Access Compliance Report

Public Rights-of-Way

(Curb Ramps)

Intersection ID: 19204	Main Street: CHARTER_PL	Cross Street: ROCKY_FALLS_RD	Location:	N
ADA ID: AF010681C1E2	Ramp Type: PerpDiag	Initial Pass/Fail: Fail	Overall Compliance: No	Severity Score: 22.5
Codes/Mitigation Info/Possible Solution		Field Measurements/Component Compliance

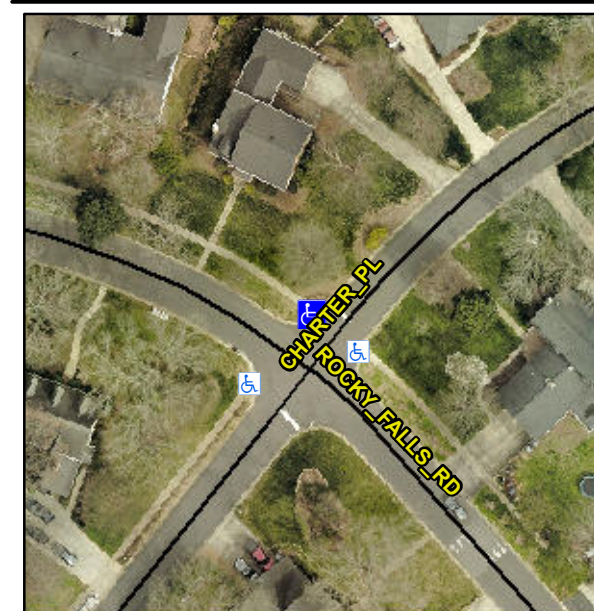
Not Found, R304.5.1, R304.2.2, R304.5.3

Compliance	Description	Data	Compliance	Description	Data
N/A	Ramp Length (in)	69.0	No	Ramp Slope (%)	9.4
No	Ramp Width (in)	47.5	No	Ramp XSlope (%)	3.4
N/A	Flare Type LT	N/A	N/A	Flare Type RT	N/A
N/A	Flare Slope LT (%)	N/A	N/A	Flare Slope RT (%)	N/A
N/A	Flare Traversable LT?	N/A	N/A	Flare Traversable RT?	N/A
N/A	Landing Length (in)	N/A	N/A	DWS Provided?	N/A
N/A	Landing Width (in)	N/A	N/A	DWS Contrast?	N/A
N/A	Landing Slope (%)	N/A	N/A	DWS Length (in)	N/A
N/A	Landing X Slope (%)	N/A	N/A	DWS Full Width?	N/A
N/A	Landing Curb? (Y/N)	N/A	N/A	DWS Offset (in)	N/A
N/A	Shared Landing?	N/A			
N/A	Gutter Ponding?	N/A	N/A	Gutter Slope (%)	N/A
N/A	Gutter Lip Ht (in)	N/A	N/A	Gutter X Slope (%)	N/A
N/A	Painted X Walk1?	No	N/A	Painted X Walk2?	No
	X Walk 1 Direction	To SW		X Walk 2 Direction	To SE
N/A	X Walk 1 Width (in)	N/A	N/A	X Walk 2 Width (in)	N/A
	X Walk 1 Slope (%)	7.6		X Walk 2 Slope (%)	0.5
	X Walk 1 X Slope (%)	2.9		X Walk 2 X Slope (%)	4.5

N/A	Ramp inside XWalk1?	N/A	N/A	Ramp inside XWalk2?	N/A
	Road Slope (%)	4.1	N/A	Clear Space?	N/A
	Road X Slope (%)	2.5	N/A	Clear Space to XWalk (in)	N/A
N/A	Any Obstructions?	N/A	N/A	Storm Grate/Utility Hazard?	N/A
	Obstruction Type			Storm Grate/Utility Type	
		N/A			N/A
			Yes	Surface Condition? (G/P)	Good

Remove & Replace Curb Ramp With Two New Directional Ramps or Equivalent.
